SUBMISSIONS REPORT

Kelso Crescent Multi-Level Warehouse, Moorebank (Amendment)

SSD-58978472

16 March 2026

Figure 2. Lower Ground Floor Plan - Amendment Report and RTS Revised Plan (Pace, 2026)

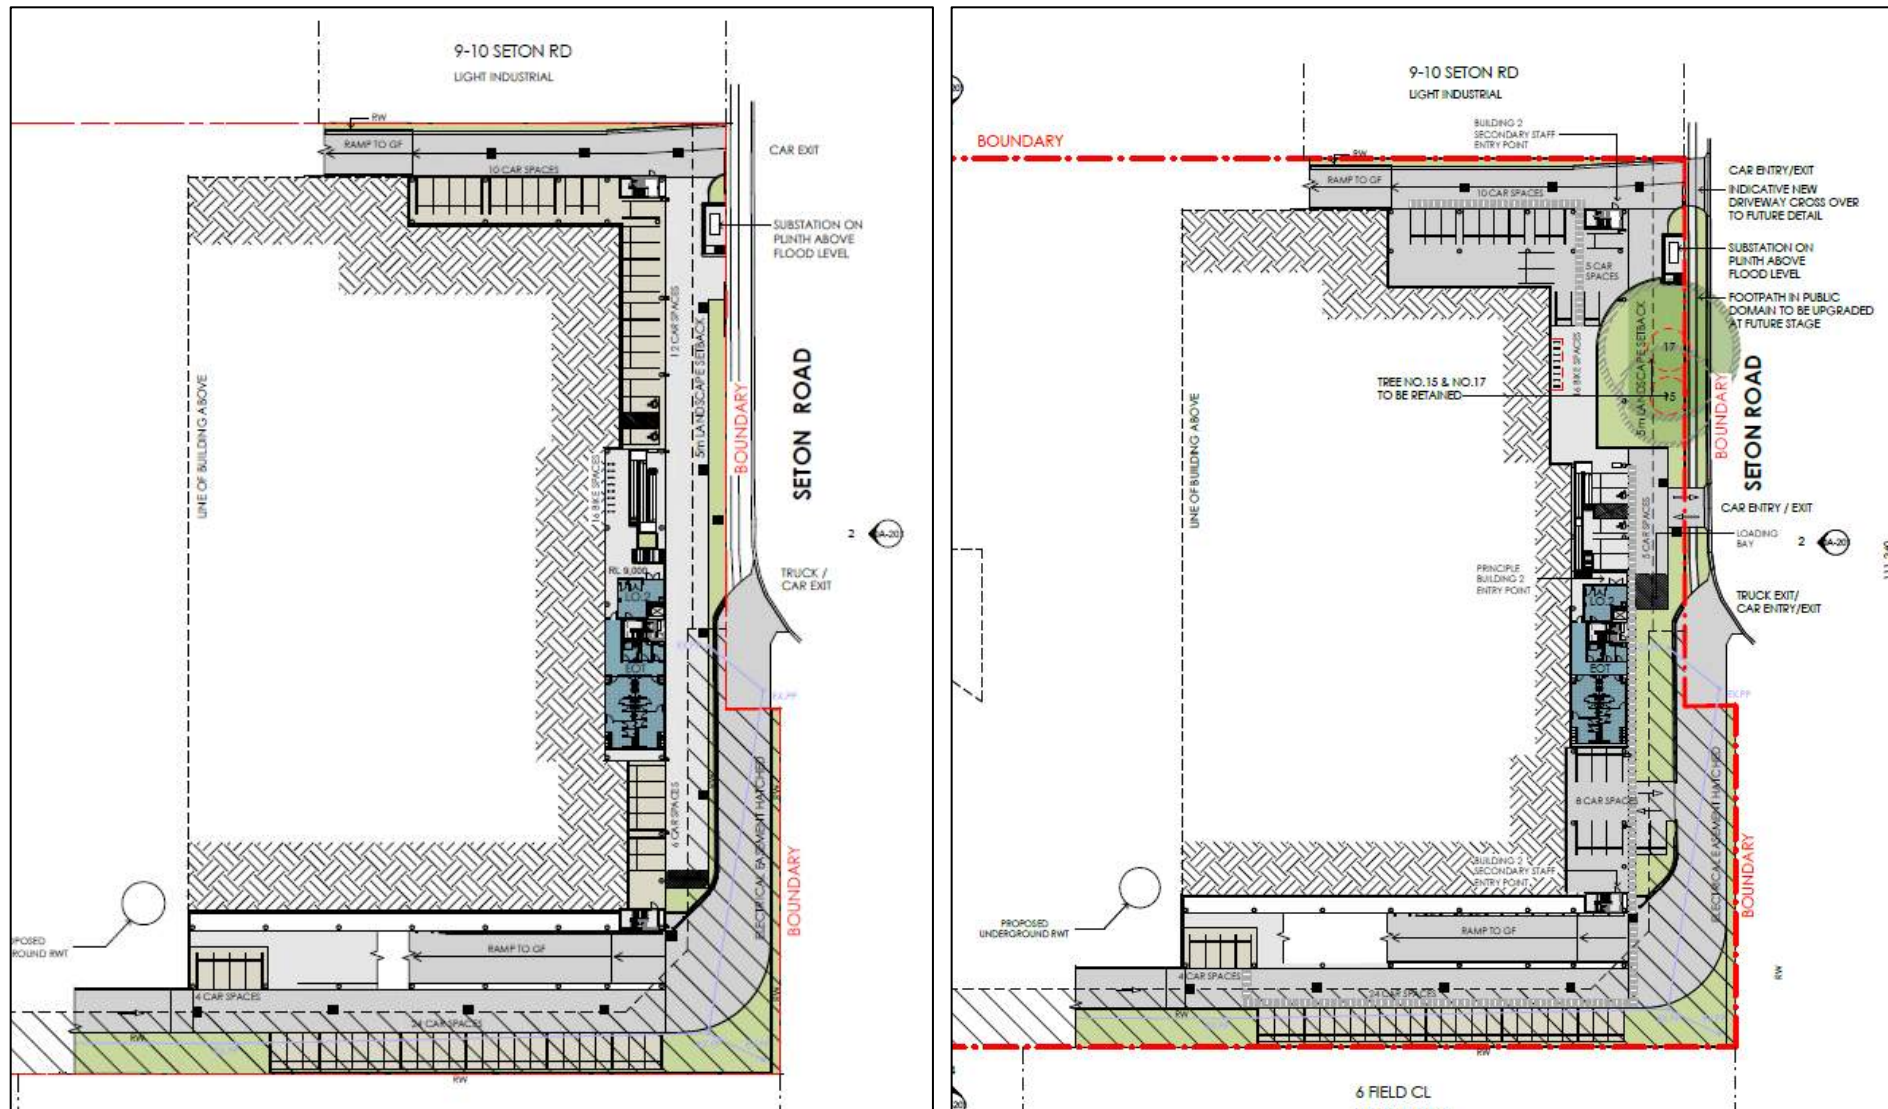
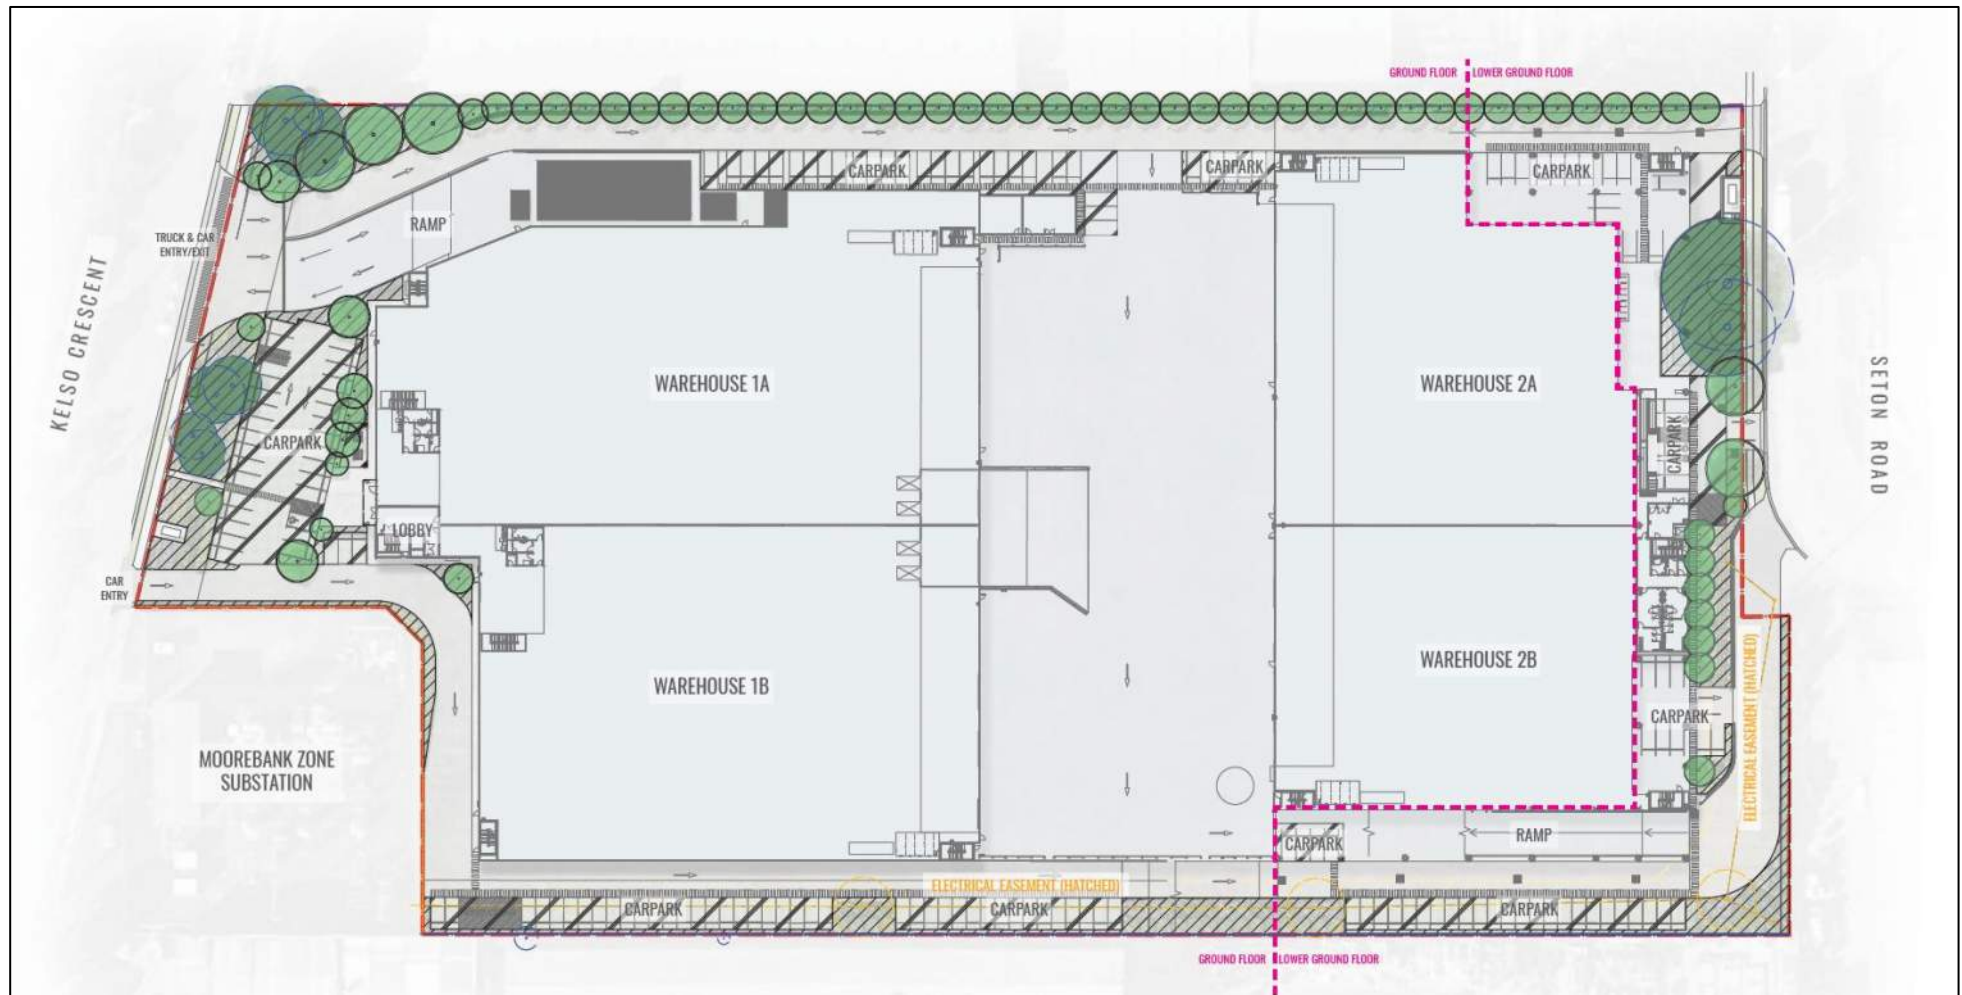
No.	Agency	Key Issues Raised	Response	Supporting Appendix/ Section
		the car park, increasing the building setback, and utilising flexible paving surrounding. The Arborist report states 'Remove' against these trees with no justification why.		
		<u>Landscape Area — DCP Non-Compliance</u> The landscape area is only 6% of the site area against the DCP minimum requirement of 10%. - Permeable paving/car parking has been incorrectly included in the landscape area calculations — counting car parking as landscape area is inappropriate. - A minimum of 10% landscape must be proposed and must not include permeable paving/car parking. - Trees must be planted in the landscape area at a minimum rate of 1 tree per 30m² of landscaped area. - Trees must be capable of achieving a mature height greater than 8m.	The total landscape area (including permeable paving) is 10.5%. The revised landscape area excluding permeable paving will be 7.3%. As noted in section 5.1 of this Response to Submissions Report, this is considered acceptable given the landscape plan includes a range of trees (including the retention of significant trees), shrubs, and ground cover, in addition to permeable paving	Section 5.1 of this RTS Appendix D3- Updated Landscape Drawings Appendix D4- Landscape Response to Submissions

The landscape design has been amended to retain trees 15 and 17 along the boundary of Seton Road – refer to **Figures 2-3**. In addition, the landscaping plan proposes to plant an additional three (3) trees along the Seton Road boundary.

Figure 4. Proposed Landscape Plan (Geoscapes, 2026)

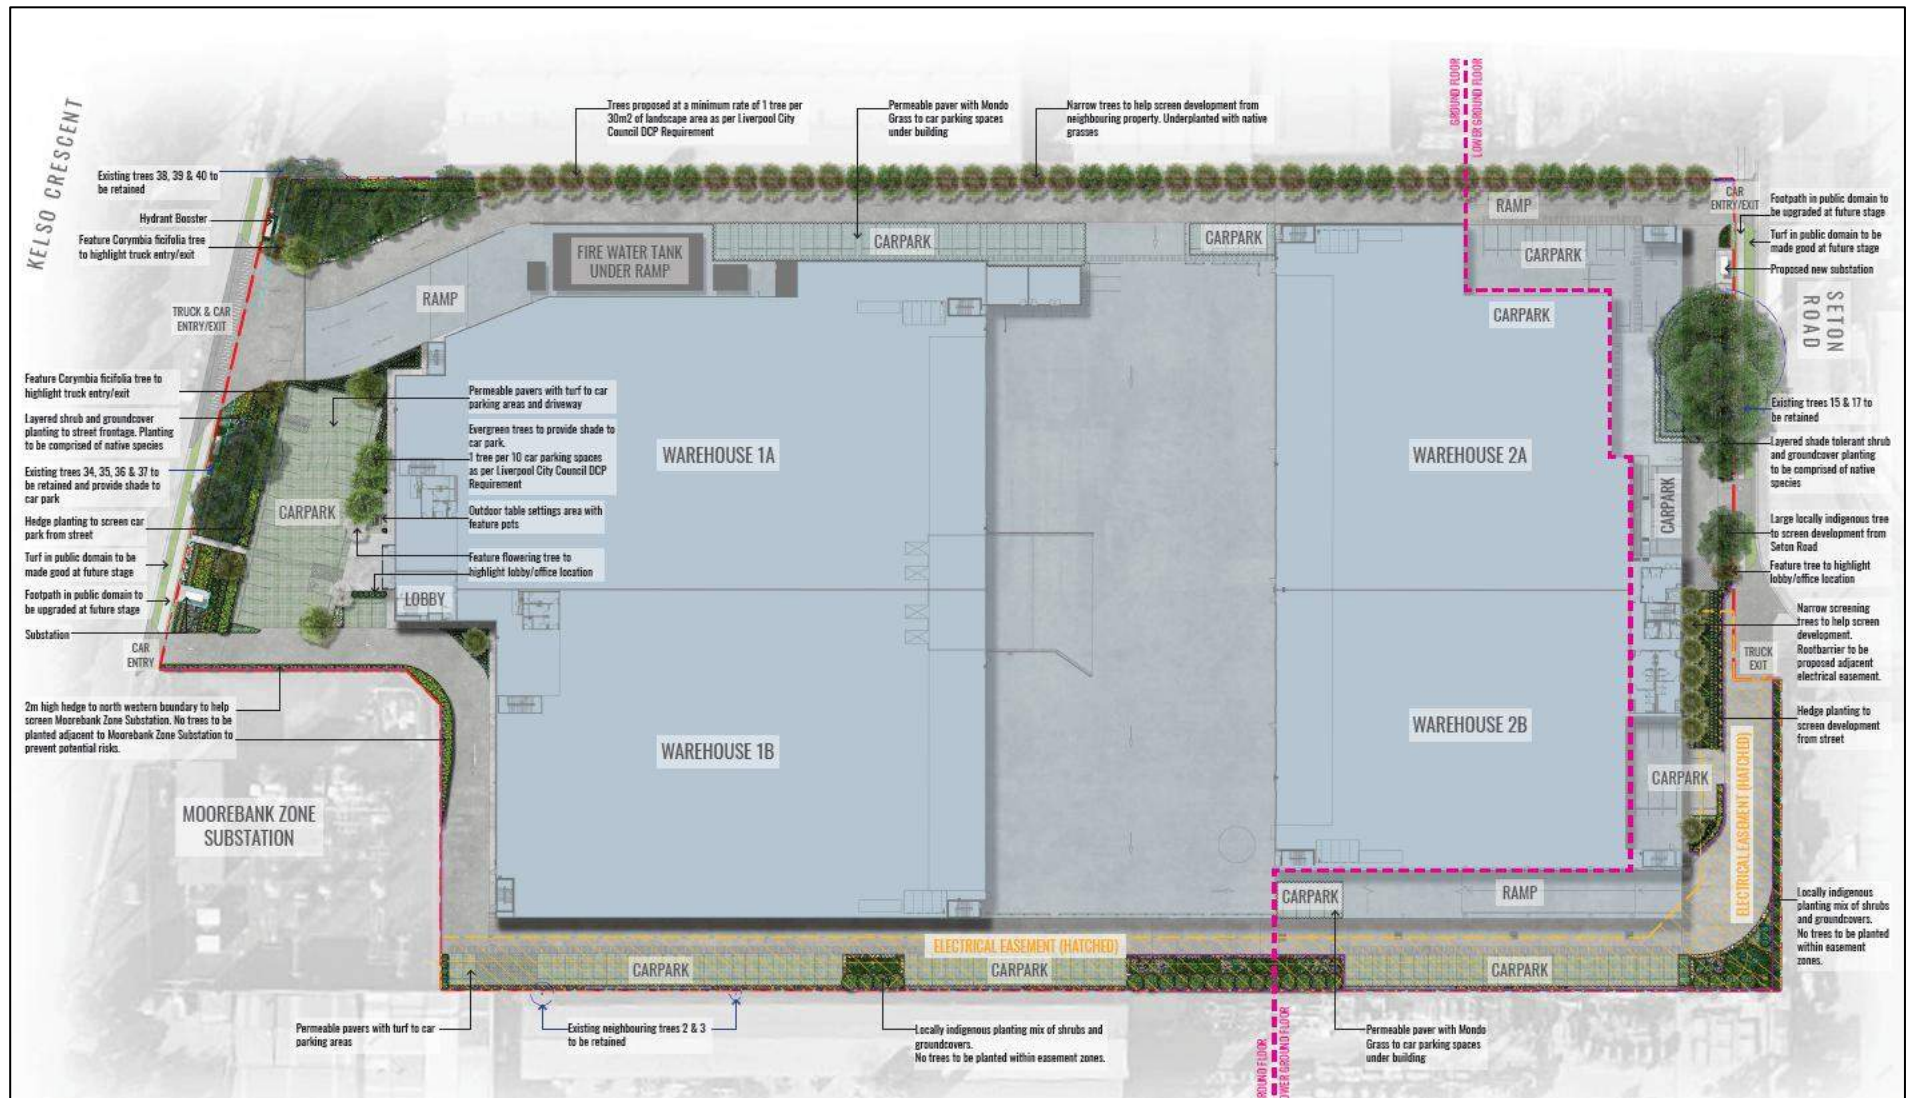
<u>City Design and Public Domain</u> - Tree Retention — Trees 15 and 17 - Landscape Area — DCP Non-Compliance - Public domain works - Pedestrian Entry Safety - Ground Levels - Solar panels	Appendix D3 - Updated Landscape Plans Appendix D4 - Landscape Response to Submissions Section 5.1 of RTS

For the proposed works outside of site, an initiative public domain plan has been provided with further detailed plans to be provided post consent in consultation with Council. Refer to drawing SSD-01, provided in Figure 4.
